# Laurelwood Data Center (19-SPPE-01)

## Data Response Set 1A (Responses to Data Requests 1 to 65 Staff Queries 1 to 17)

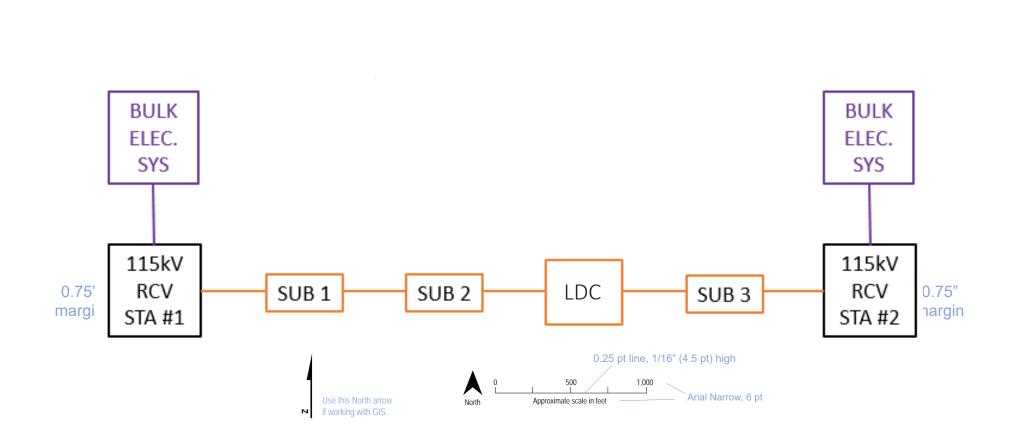
**Response:** The results of the USGS 7.5' quadrangle map were submitted March 25, 2019 and March 26, 2016 under a request for confidential designation.
